RENESAS TECHNICAL UPDATE

Product Category	MPU/MCU		Document No.	TN-V85-A006A/E	Rev.	1.00
Title	Note about the RYO output delay time of the clock synchronous serial interface (CSIH, CSIG)		Information Category	Technical Notification		
Applicable Product	V850E2/Px4 series V850E2/Px4-L series	Lot No. All lots	Reference Document	User Manual of each product

Figure 1. CSIGnSC/CSIHnSC and CSIGnRYO/CSIHnRYO timing chart

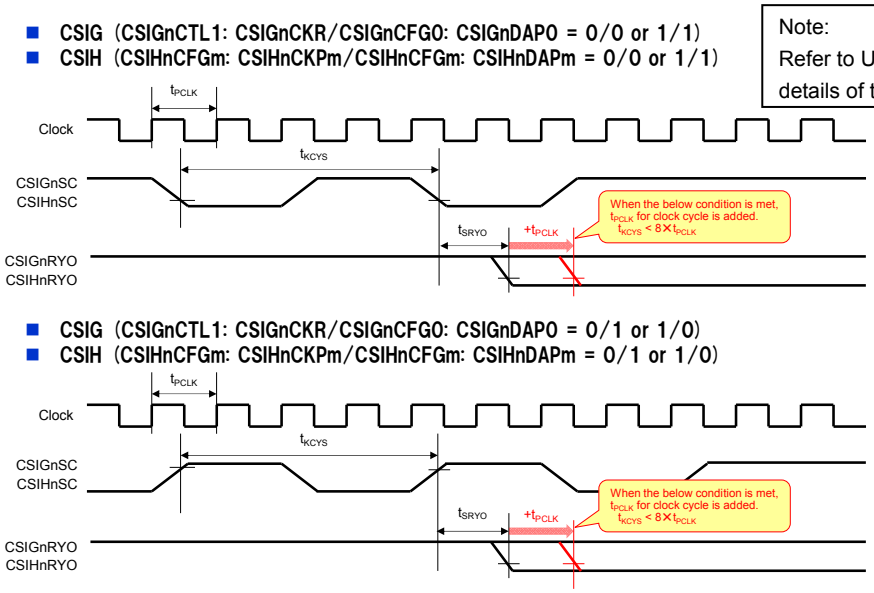
(1) Electrical characteristic change at the CSIG slave mode (RYO output delay).

When CSIGnSC cycle time (tKCYS) is smaller than 8 times of the PCLK cycle (tPCLK) as following figure 1,

1 cycle tPCLK is added to the RYO output delay (tSRYO).

(2) Electrical characteristic change at the CSIH slave mode (RYO output delay).

When CSIHnSC cycle time (tKCYS) is smaller than 8 times of the PCLK cycle (tPCLK) as following figure 1,

1 cycle tPCLK is added to the RYO output delay (tSRYO).

The CSIGnRYO output delay (tSRYO) is changed as below.

Item	Symbol	Conditions	MIN.	TYP.	MAX.	unit
CSIGnRYO output delay	t_{SRYO}	tKCYS ≧ 8×tPCLK			30	ns
		tKCYS ＜ 8×tPCLK			30 + t_{PCLK}	ns

The CSIHnRYO output delay (tSRYO) is changed as below.

Item	Symbol	Condition	MIN.	TYP.	MAX.	unit
CSIHnRYO outout delay	t_{SRYO}	tKCYS ≧ 8×tPCLK			30	ns
		tKCYS ＜ 8×tPCLK			30 + t_{PCLK}	ns

The CSIGnRYO output delay (tSRYO) is changed as below.

Item	Symbol	Condition	MIN.	TYP.	MAX.	unit
CSIGnRYO output delay	t_{SRYO}	tKCYS ≧ 8×tPCLK			30	ns
		tKCYS ＜ 8×tPCLK			30 + t_{PCLK}	ns
